The Sizewell C Project

6.14 Environmental Statement Addendum Volume 3 Environmental Statement Addendum Appendices Chapter 2 Main Development Site Appendix 2.15.A: Coastal Processes Monitoring and Mitigation Plan - Tracked Changes Version

Revision: 3.0
Applicable Regulation: Regulation 5(2)(a)
PINS Reference Number: EN010012

September 2021

Figure 1: Marine components of SZC and the intake and outfall locations for Sizewell B. The dark black lines east and north of Sizewell C mark the HCDF. [SZC mark the HCDF (not temporary BLF is now named MBIF)]

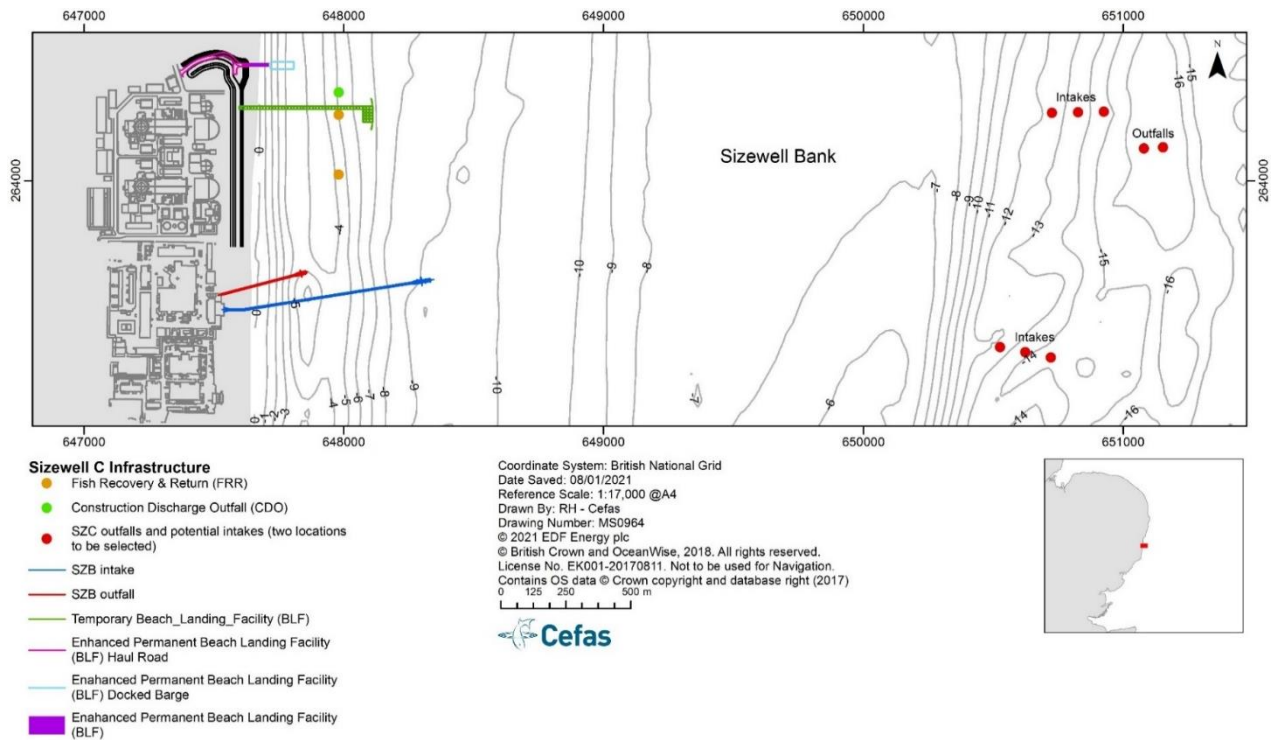
Note: 1 that recent design changes bring the abutment at the BLF landwards to align with the main HCDF, and the HCDF seaward too further landward than shown, to approximately 647620E, however engineering drawings were not available when this report was produced. This figure will be updated in the next version of this report. Note 2: Permanent BLF = BLF and Temporary BLF = MBIF}}

Figure 9: Beach Landing Facility (BLF) shown together with a docked barge.

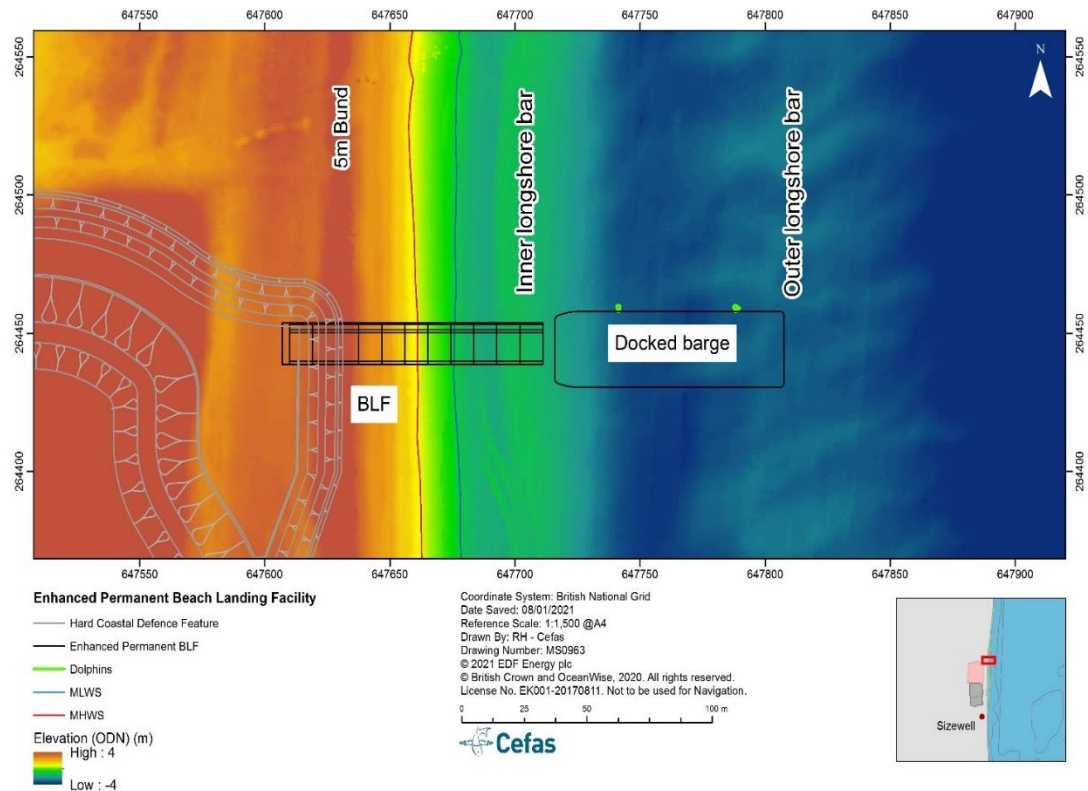
~~1.1.15.1.1~~ The enhanced BLF consists of a 101 m long piled ~~deck~~ jetty that abuts to the haul road on the ~~5.2~~ 5.4 m ODN platform of the HCDF. The HCDF – BLF abutment protrudes further seaward (see Figure 1 and Figure 9) to accommodate the haul road and the turning radius required for Abnormal Indivisible Load (AIL) vehicles. The last 50 m of the BLF ~~deck would~~ jetty

[Note 1: that recent design changes bring the abutment at the BLF landwards to align with the main HCDF, and the HCDF seaward too further landward than shown, to approximately 647620E, however engineering drawings were not available when this report was produced. This figure will be updated in the next version of this report. Note 2: Permanent BLF = BLF]

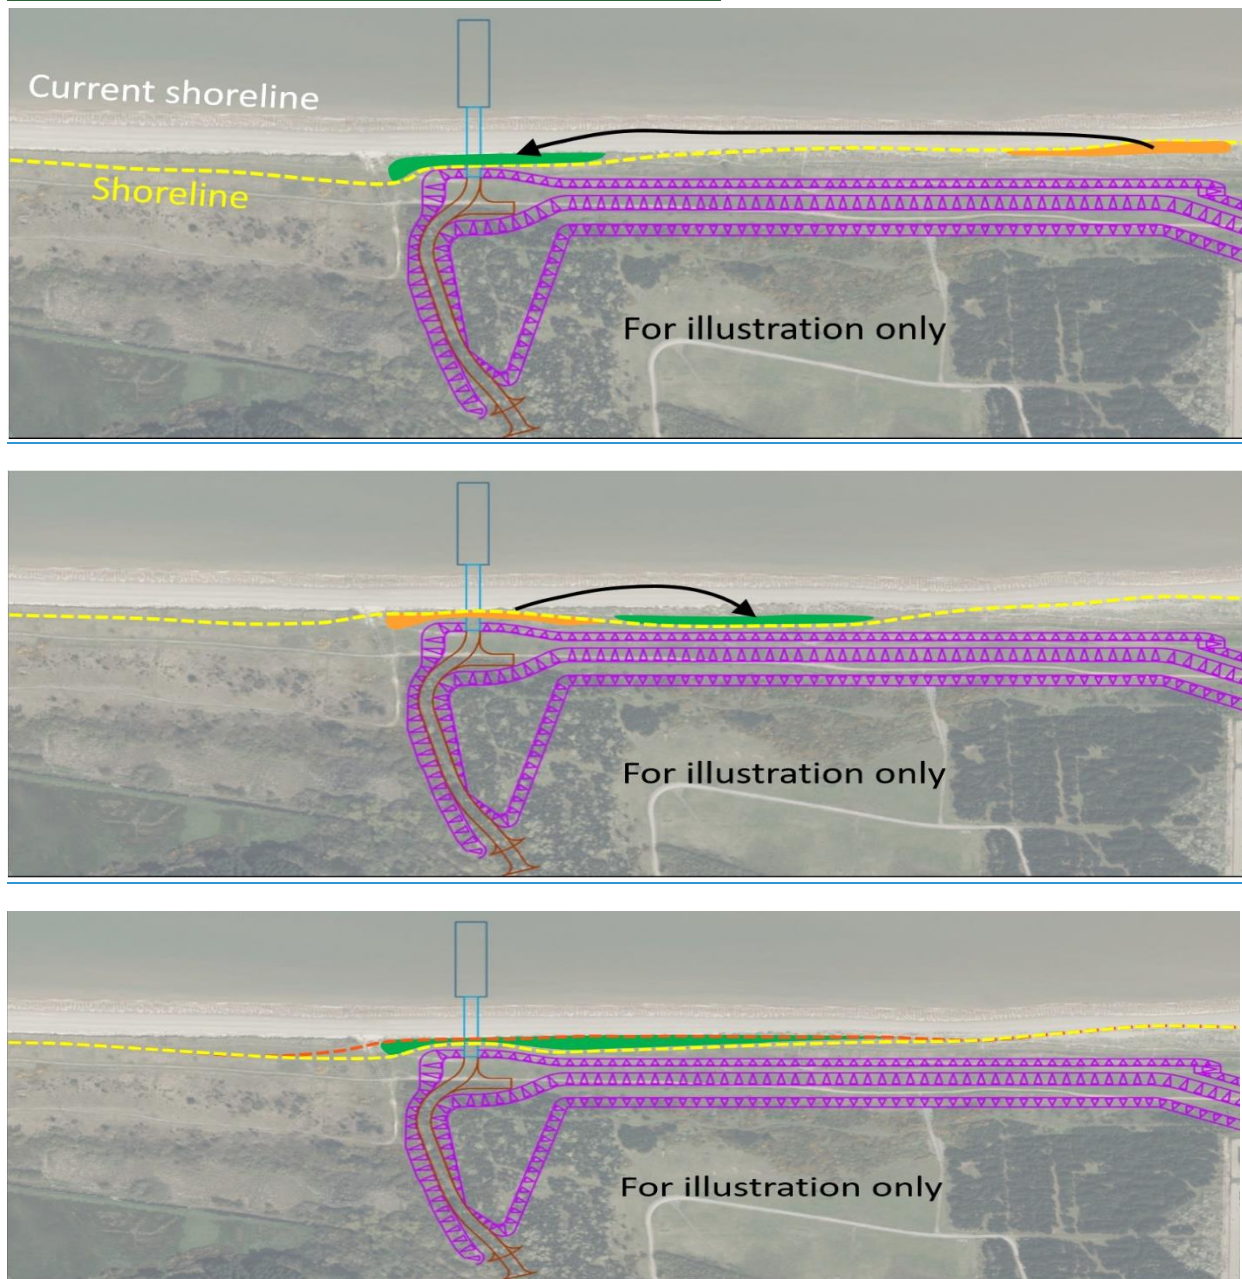
~~Figure 12: Schematics showing examples of depleted beach sections and the likely mitigation method: beach recycling (top), sediment bypassing (middle) and beach recharge (bottom). The examples assume a net southerly (left to right) longshore drift, but the same principles can be applied in the unlikely event of any period of persistent reversal in the net transport direction. Orange indicates the borrow area and green the deposition area. [Note that recent design changes bring the abutment at the BLF landwards to align with the main HCDF, and the HCDF seaward toe further landward than shown, to approximately 647620E, however engineering drawings were not available when this report was produced. This figure will be updated in the next version of this report.]~~
